HISTORIC AND DESIGN REVIEW COMMISSION

September 6, 2023

HDRC CASE NO: 2023-305
ADDRESS: 421 SPOFFORD
LEGAL DESCRIPTION: NCB 1266 BLK 2 LOT C
ZONING: R-6, H
CITY COUNCIL DIST.: 2
DISTRICT: Government Hill Historic District
APPLICANT: Shail Patel
OWNER: Shail Patel and Blake McCall Bratcher
TYPE OF WORK: Concrete installation, curb cut modification, and carport construction
APPLICATION RECEIVED: July 25, 2023
60-DAY REVIEW: September 23, 2023
CASE MANAGER: Bryan Morales

1 M. SITE PLAN - CARPORT ADDITION
3/32" = 1'=0" @ 11x17

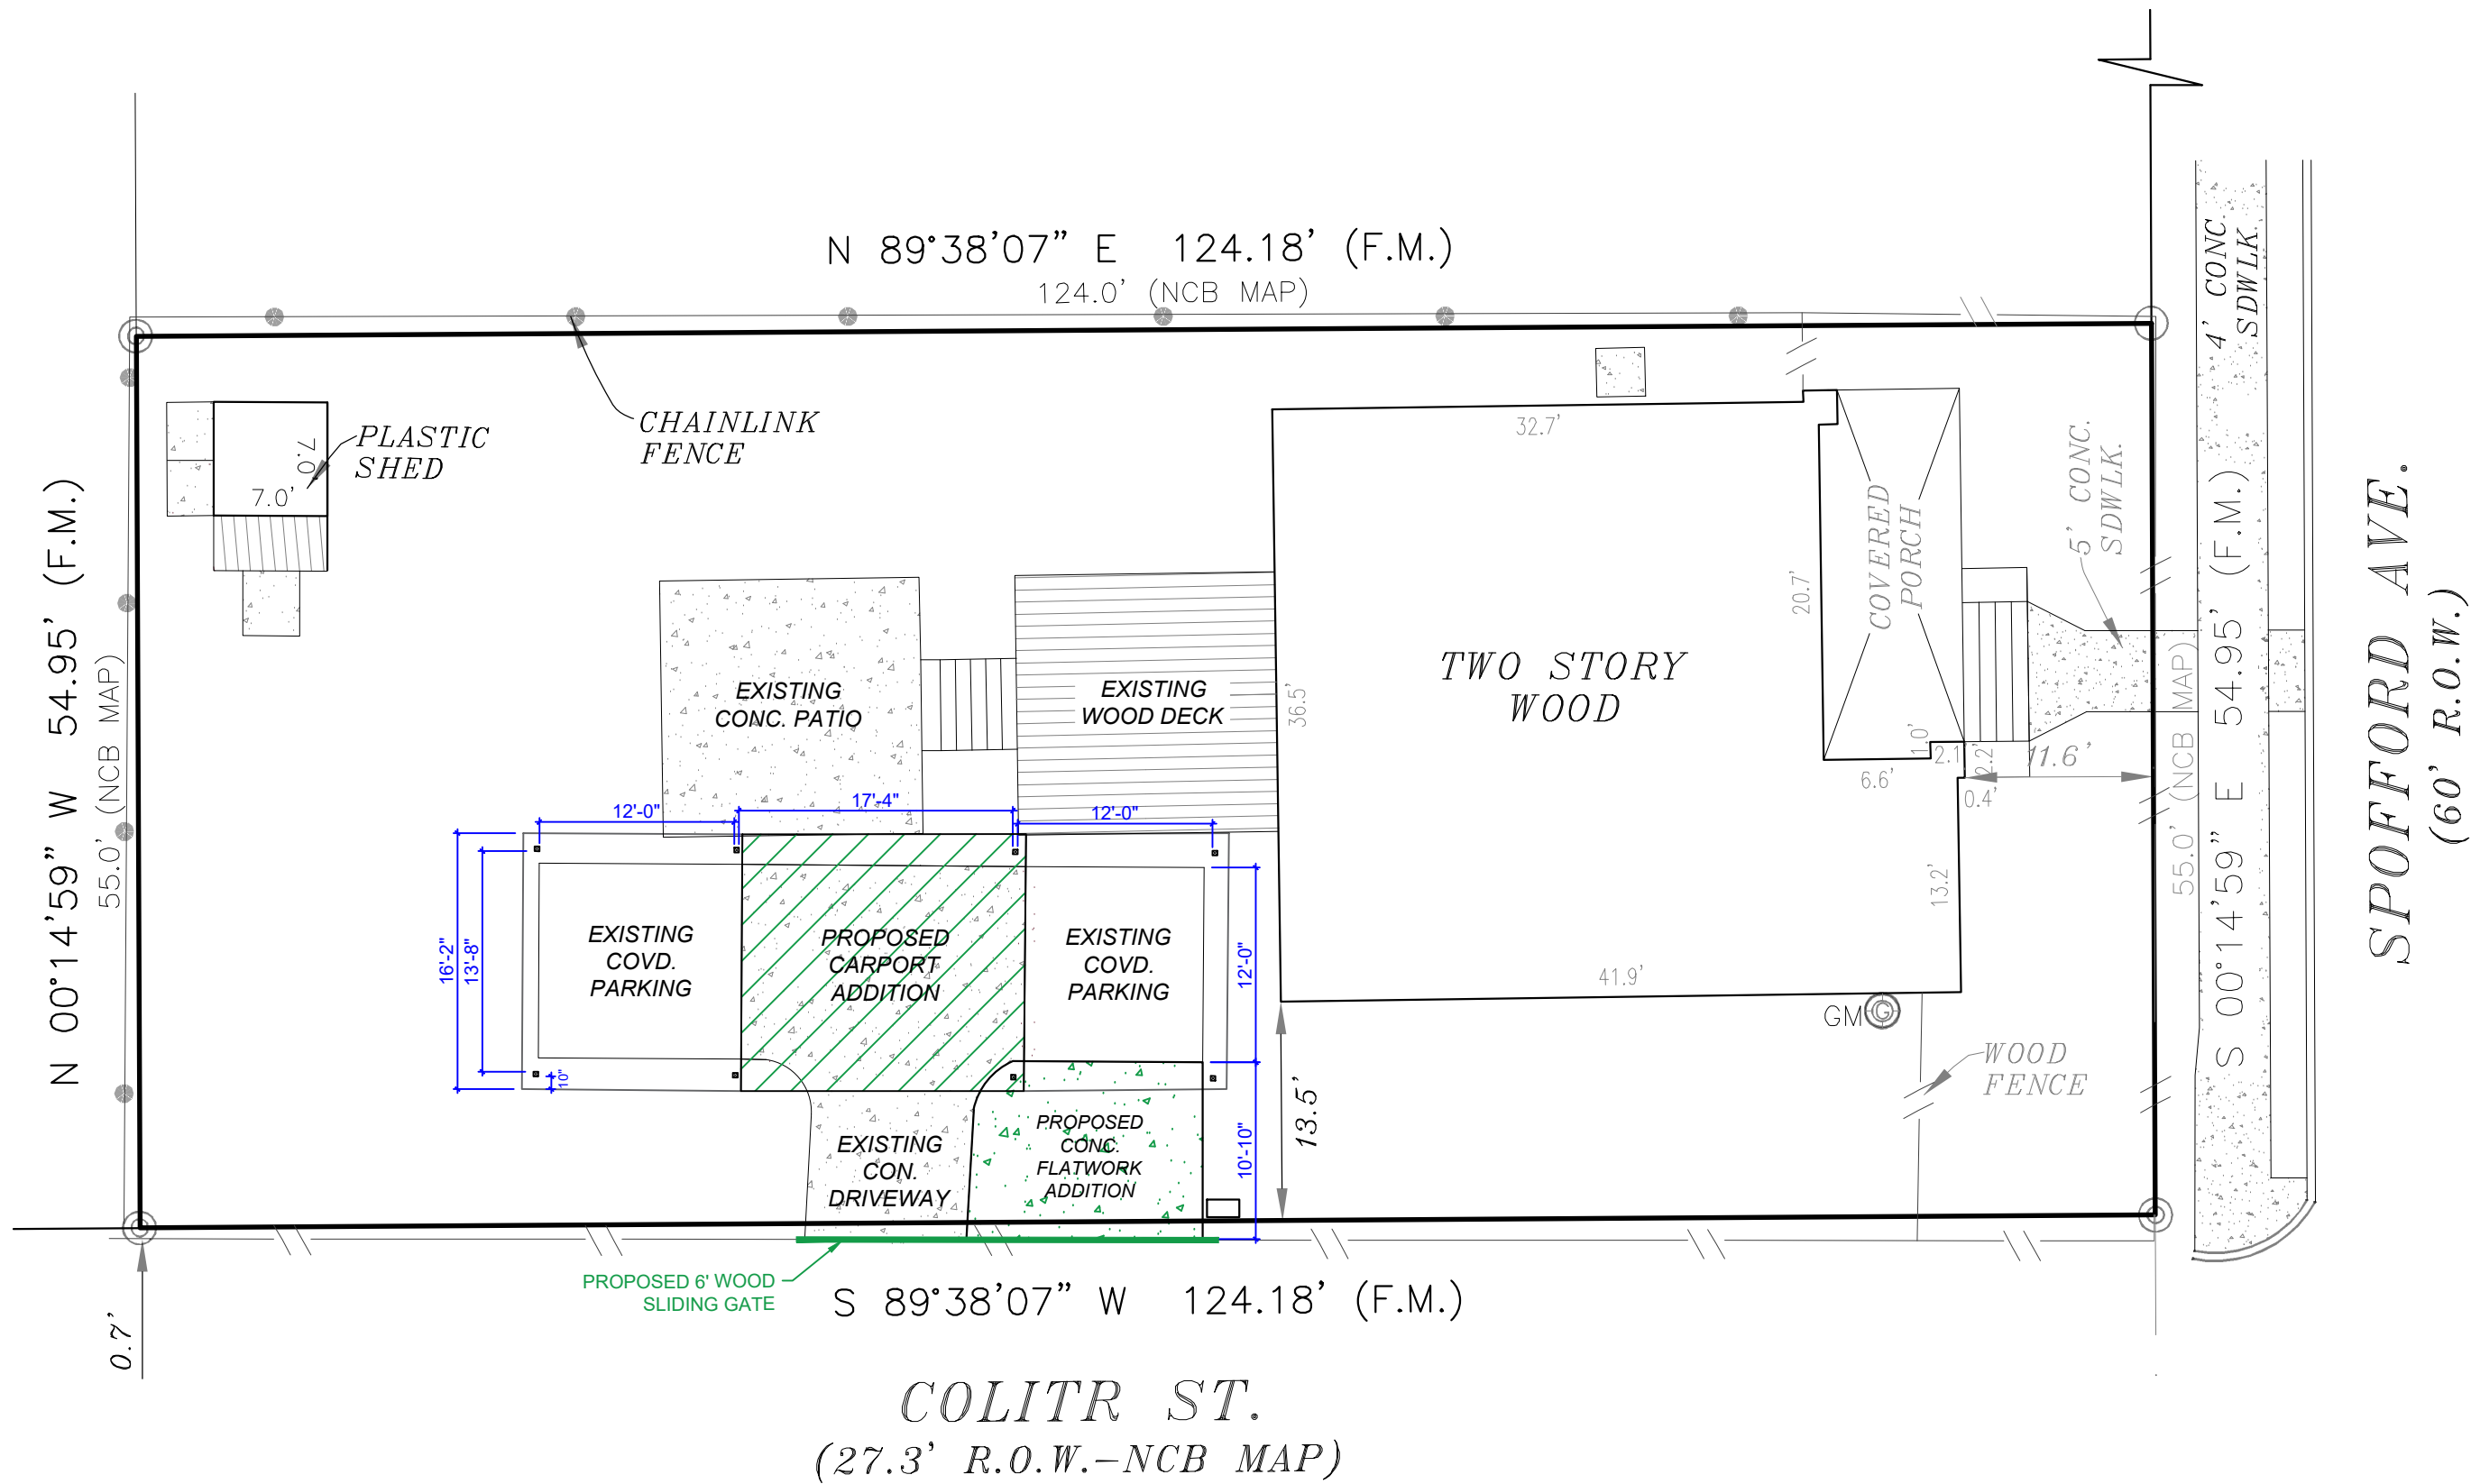
- e. DRIVEWAY & CURB CUT – The applicant is requesting to increase the rear driveway and curb cut width from 9’10” to 23’10” on Colita Street. The Historic Design Guidelines for Site Elements 5.B.i. states to retain and repair in place historic driveway configurations, to incorporate a similar driveway configuration – materials, width, and design – to that historically found on the site, and that historic driveways are typically no wider than ten feet. Guidelines for Site Elements 5.B.ii. states to maintain the width and configuration of original curb cuts when replacing historic driveways and to avoid introducing new curb cuts where not historically found. Staff finds the width increase for the driveway and curb cut does not conform to guidelines.

Staff does not recommend approval of item 2, based on findings a through e, consistent with the previous HDRC decision on May 1, 2019. Staff recommends that the applicant retain the current driveway and curb cut configuration.

1 PLAN & ELEVATIONS - CARPORT ADDITION
1/4" = 1'=0" @ 11x17

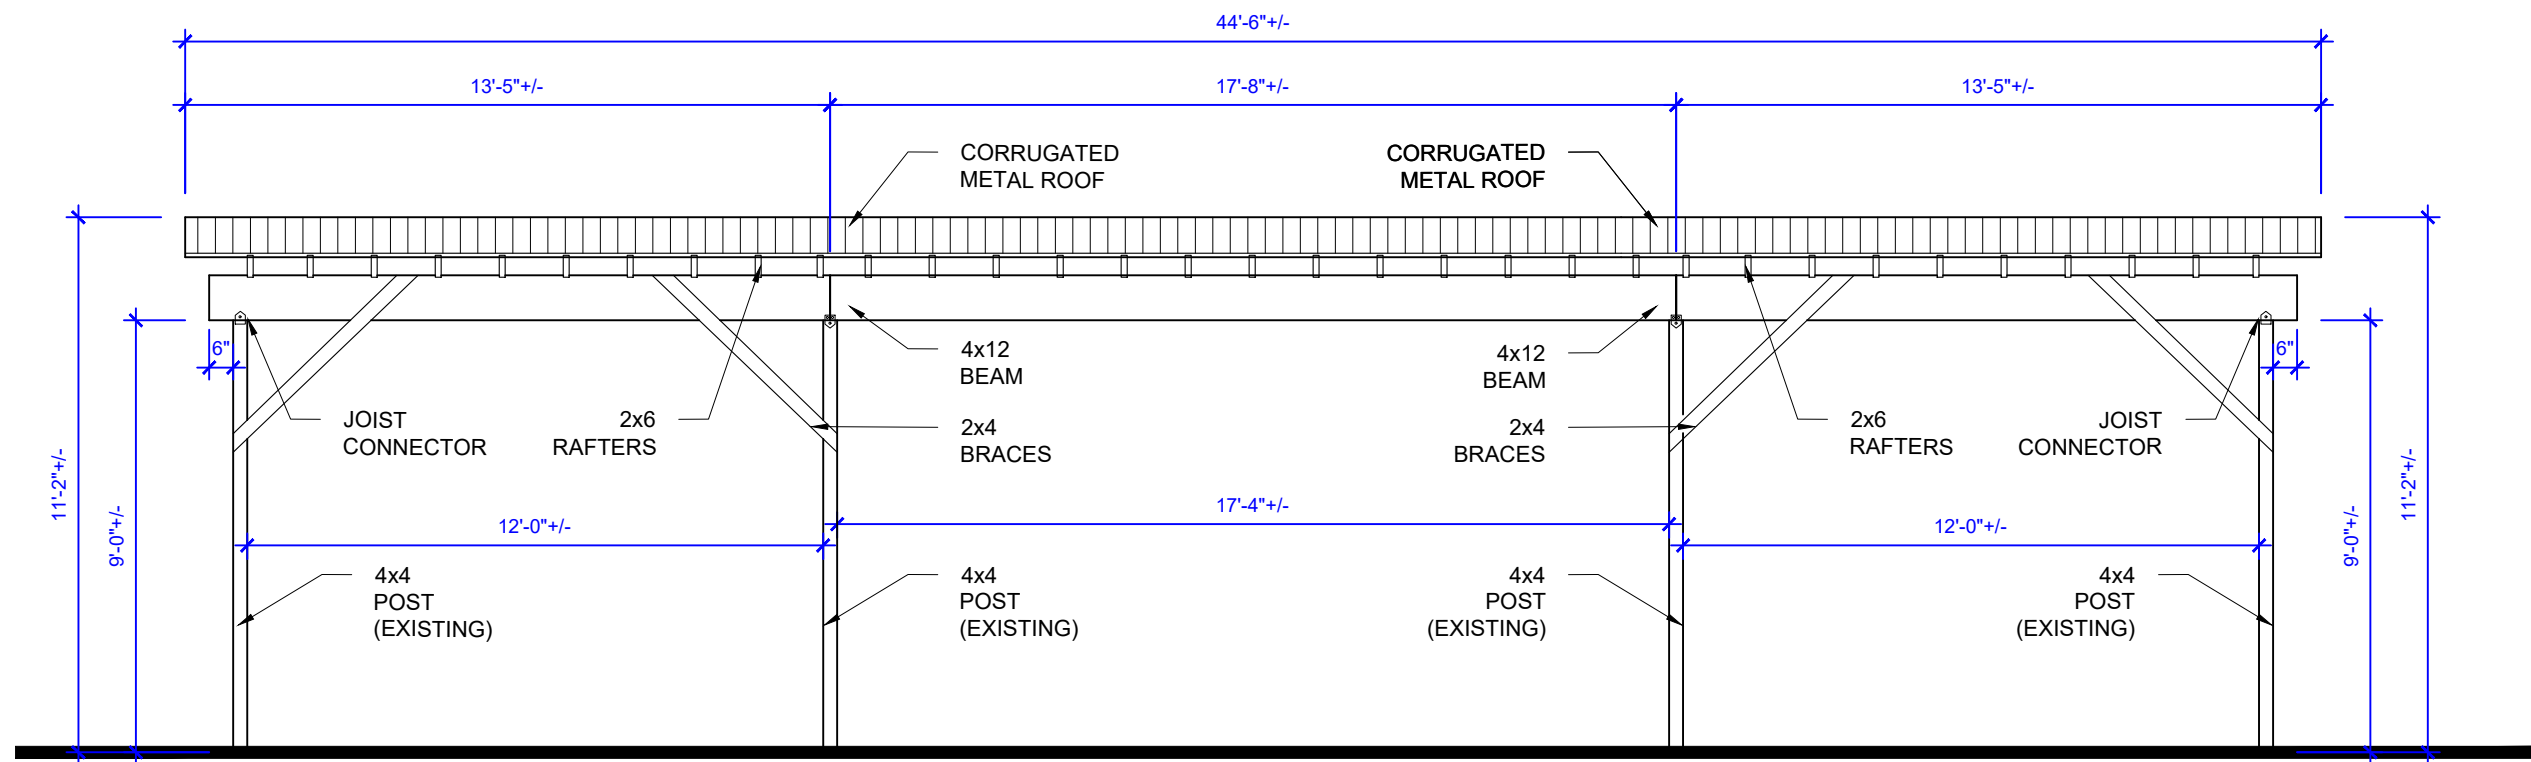
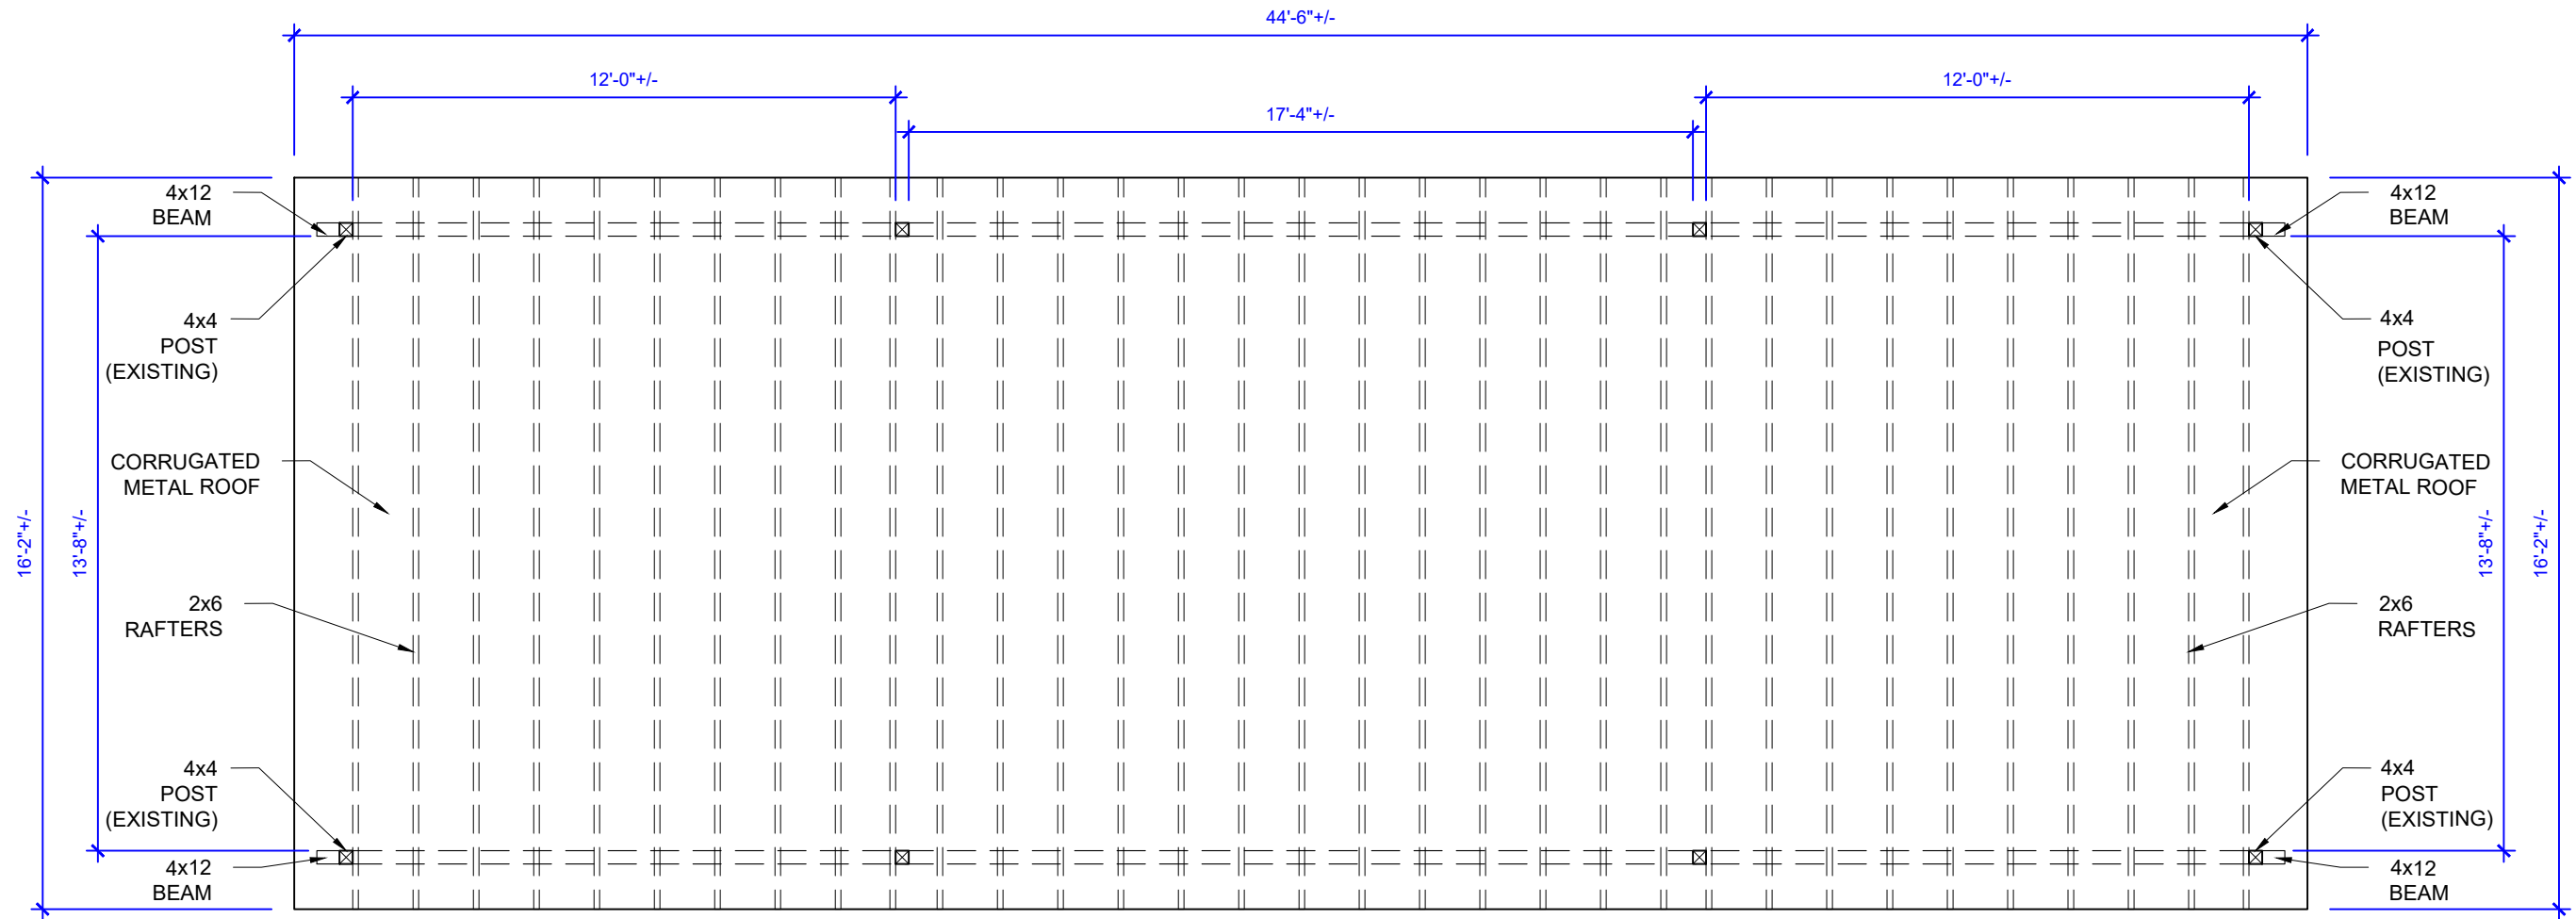
- c. **CARPORT** – The applicant is requesting to construct a 17'4" by 16'2" carport at the rear of the property. The Historic Design guidelines for New Construction 5.A.iii. stipulates that new garages and outbuildings must relate to the period of construction of the principal building on the lot through the use of complementary materials and simplified architectural details. Additionally, New Construction 5.A.ii. states that new structures should be no larger in plan than 40 percent of the principle historic structure footprint. Staff finds that the proposed carport generally appropriate.

- d. **CARPORT (MATERIALS)** – The applicant is requesting to construct a carport at the rear of the property using 4x4" wood posts and a corrugated metal roof. Guidelines for New Construction 5.A.iii. stipulates that new garages and outbuildings must relate to the period of construction of the principal building on the lot through the use of complementary materials and simplified architectural details. Staff finds the installation of a corrugated roof generally appropriate; however, the carport should feature posts measuring 6x6" rather than the proposed 4x4" posts.

- i. That the applicant uses 6x6” wood posts rather than the proposed 4x4” wood posts.
